CITY OF YAMHILL, CITY PLANNING COMMISSION MEETING **City of Yamhill Council Chambers, 205 S Maple St., Yamhill, OR 97119 & Zoom** **Wednesday, April 5, 2023** **7:00 PM**

STAFF REPORT

SUBJECT: Planning File – Gas Station/Convenience Store (DR 23-01)

DATE: March 28, 2023

FRONT ELEVATION

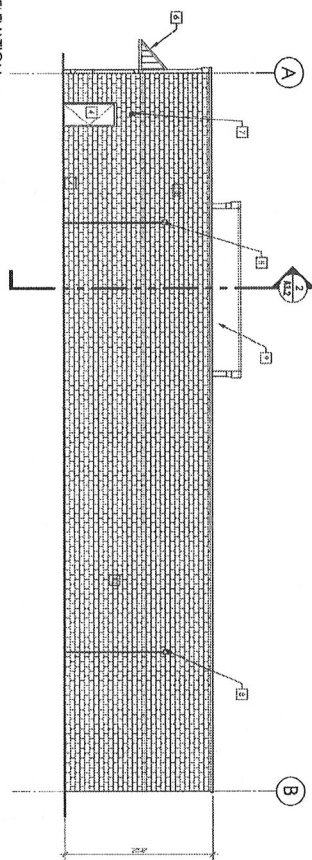
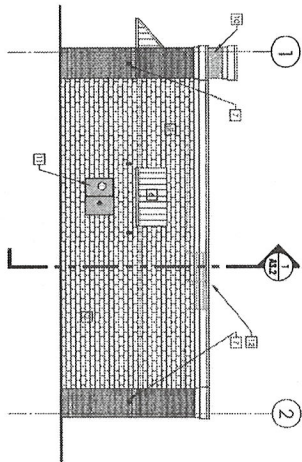
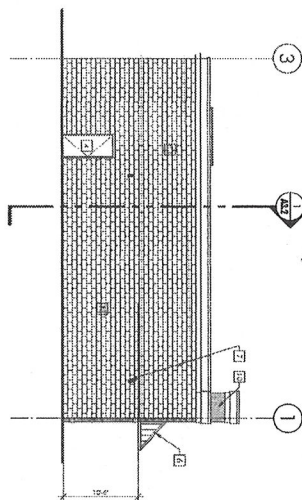
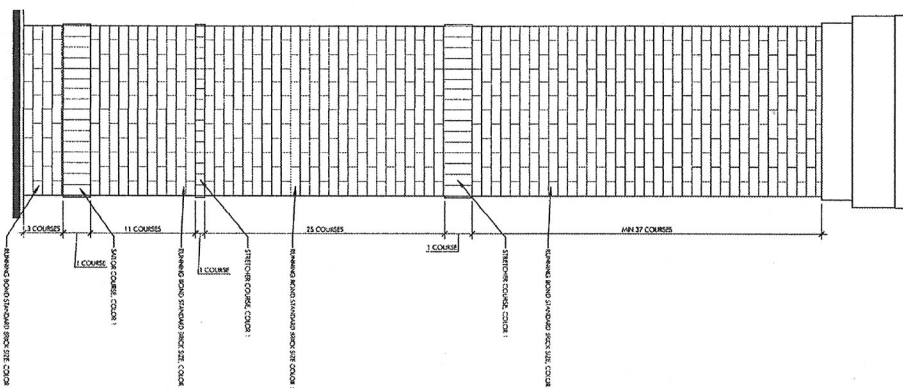
FINDINGS: The structure complies with this Section, as the façade combines brick veneers and split-faced CMU to create a masonry finish.

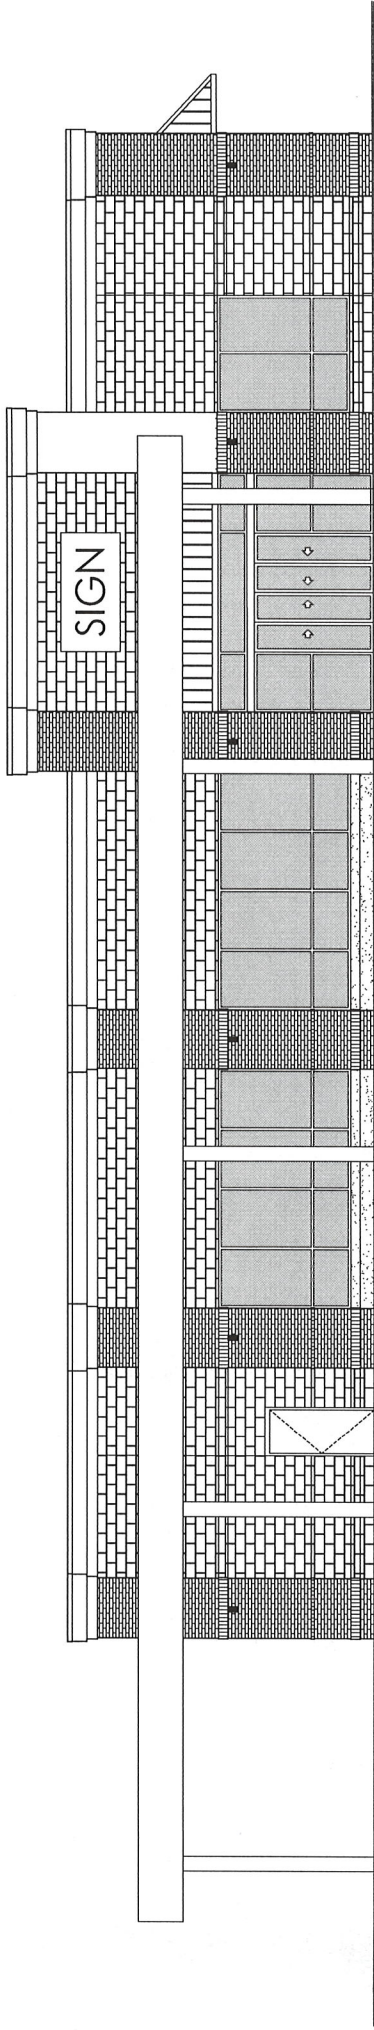
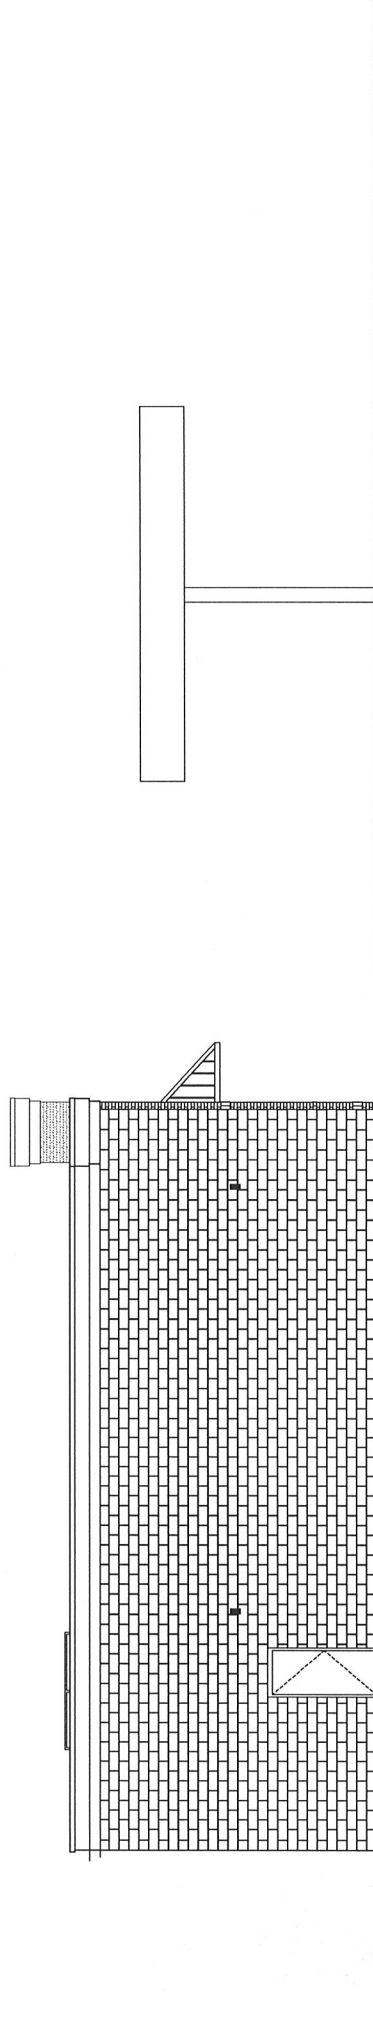
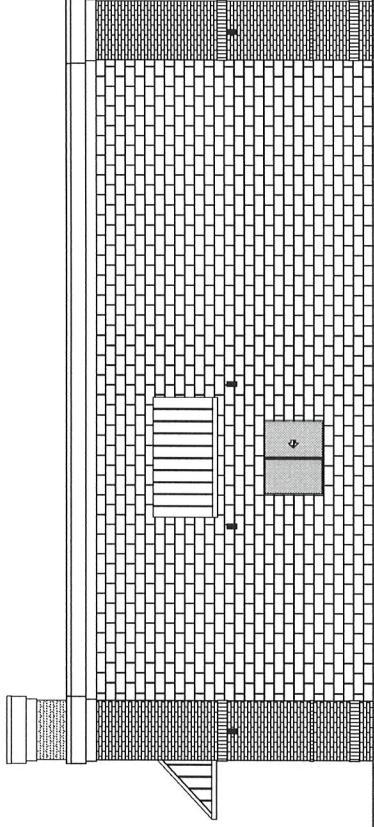
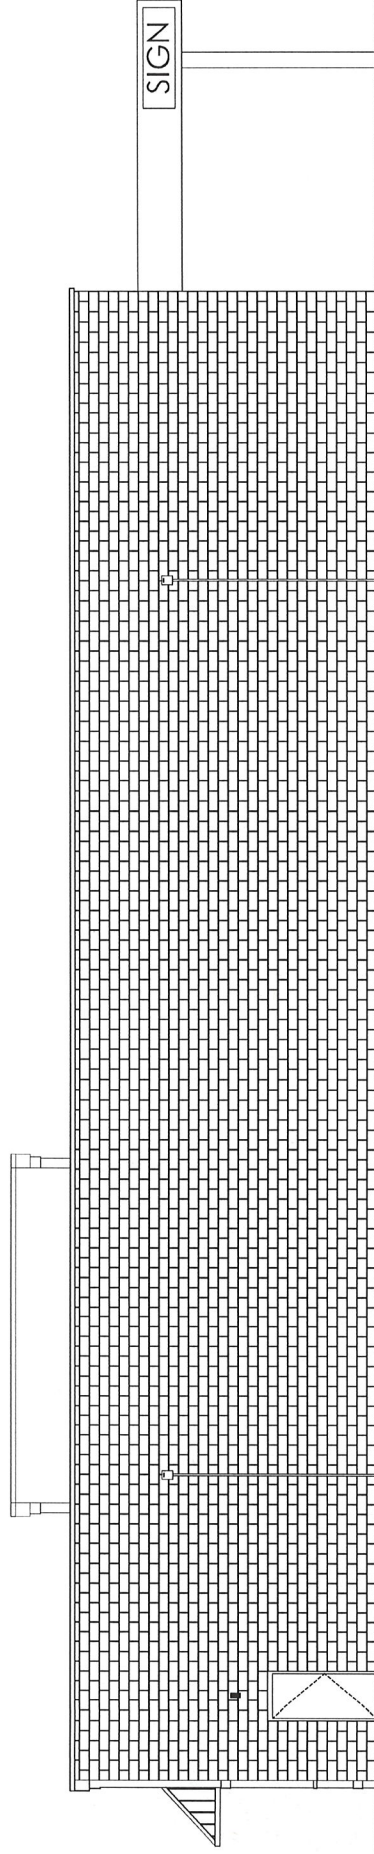
FINDINGS: The building complies with the 0-foot setback requirement on Maple Street. Within the block, the “Front Elevation Plans” show the roof line is approximately equal to the structures to the south.

The submitted “Front Elevation Plans” also shows the adjacent four buildings having their main entrance facing the street. In contrast, the proposed building’s Maple Street frontage is a brick wall without an entrance or windows. This is in stark contrast to the existing structures.

3. Design/Façade – The submitted plan comparing building elevations along the block showed the main building entrances fronting Maple Street. Not so with the proposed structure. Although allowed, this raises the question as to whether the design is “. . . similar in character and design with existing structures.” Further, it is not just the doors facing the street, but the frontage includes significant window features, again something that is lacking in the proposal.
